**Zimmer Spine**

### NOTIFICATION OF A MEDICAL DEVICE CORRECTION

Zimmer reference: 2184052-10-02-2013-002-R

**Subject**: Sterilization of the Ratchet Handles used with the Trinica® ALP System

### Cannulated ratchet handles (Item #07.00438.001) indicated by arrows, below:

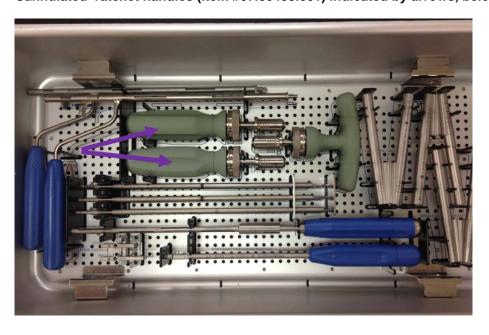
Zimmer Spine, Inc. is initiating a device correction/ notification regarding the Trinica ALP Instrument Tray, part 07.01058.001 (all lots) distributed from September 11, 2006 through April 29, 2013. The Ratchet Handles, part 07.00438.001 may not be effectively sterilized if left in their designated location(s) in the instrument tray. This is due to the current bracketing in the tray potentially interfering with complete steam penetration into the cannulated handle. To assure effective sterilization, the Ratchet Handles must be sterilized **external** to the instrument tray. This issue was identified during an internal Zimmer Spine engineering evaluation. No complaints have been reported.

- a) Review this notification and ensure affected personnel are aware of its contents.
- b) Only sterilize the Ratchet Handles <a href="external">external</a> to the instrument tray. It is recommended that high temperature steam sterilization be used, following AAMI/ISO Steam Sterilization standards and a validated cycle. Please refer to Trinica ALP IFU, 07.01085.001. Please note that local or national specifications should be followed where steam sterilization requirements are stricter or more conservative than those listed in this table.
